## **Response to Meadow Way Bridge Residents' Comments from the January 2018 Survey**

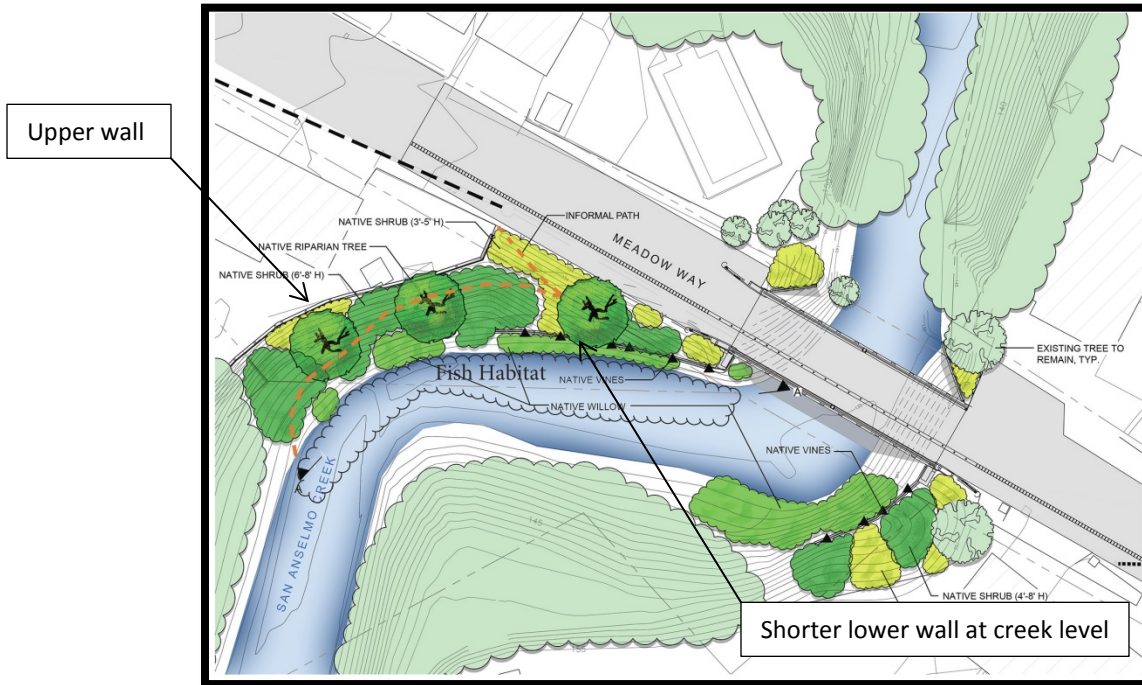
**Comment: Fish habitat is crucial!**

Response: This is one of the most fish-friendly projects in the watershed. It will create fish pools, the revetment, plants, and nooks and crannies that create refuge, cooler water and shade to facilitate fish migration during spawning times.

New Wall Plan

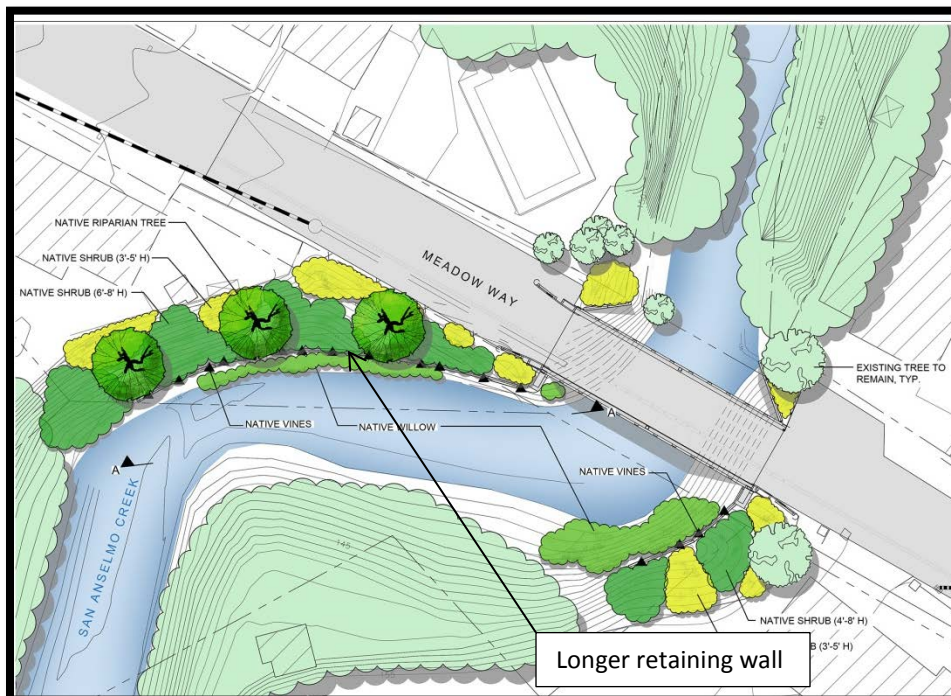
**Comment: On the Retaining Wall Location and Layout Plan, it would be helpful to notate each of the walls and provide the 'old plan' alongside the 'new plan'.**

Response: Please see the exhibits below.
